#### VICTORIAN CIVIL AND ADMINISTRATIVE TRIBUNAL

VCAT REFERENCE NO. P954/2024 PERMIT APPLICATION NO.TPA/55463

**SUBJECT LAND** 235-237 High Street Road

CITATION Aym Au Pty Ltd v Monash CC [2025]

Figure 2 - extract of ground floor plan showing rear setback

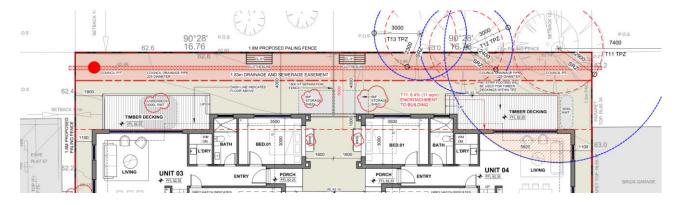
- Finally, the council is critical that the rear setback of dwellings 3 and 4 does not, in part, meet the minimum rear setback of five metres as required by clause 55.04-1 when read with the GRZ3 schedule. When combined with the location of a sewer easement in this rear setback, the council submits there is insufficient landscaping and space to create a green spine as sought by the character objectives.

- 31 The rear setback includes a bedroom to each of dwelling 3 and 4 that is set back only four metres from the rear boundary. In reviewing the rear setback the council submits that a small section of the upper level is also within five metres. The remainder of the development is setback the standard five metres.

- To the west is a dwelling that is setback just over four metres from its rear boundary. To the east is a garage with wall on boundary set back about five metres from its rear boundary. The landscape plan shows three canopy trees in the rear setback area, all planted outside of the easement. There is then smaller hedge planting in the easement. A canopy tree is proposed centrally, so it will be seen between the two dwellings when viewed up the central driveway. There is a small conflict with the location of a storage shed in this location, within dwelling 3, but this is a minor issue that can be resolved through permit condition.

- The objective of the rear setback requirement is to respect the preferred neighbourhood character and avoid unreasonable amenity impacts. The encroachment of the setback from ground or upper level creates no unreasonable amenity impacts as the proposed development sits south of the adjoining rear yards and slightly down slope, so any visual bulk or shadow impacts are minimised.

- I remain satisfied from the landscape evidence that the setback can accommodate a landscape response commensurate with the character and landscape policies of the scheme. Mr Thompson acknowledged that a larger space could lead to larger planting but he is satisfied the proposal as presented is acceptable.

- The proposed planting is in the area where the five metre setback is provided and is planting that exceeds the size requirements of the GRZ3 schedule. The layout of the proposal to provide SPOS areas to each side boundary means that there is opportunity for landscaping in between the three dwellings along each side of the central driveway. This ensures there is some planting that will be visible on broader view along the side boundaries from the street and adjoining rear yards.
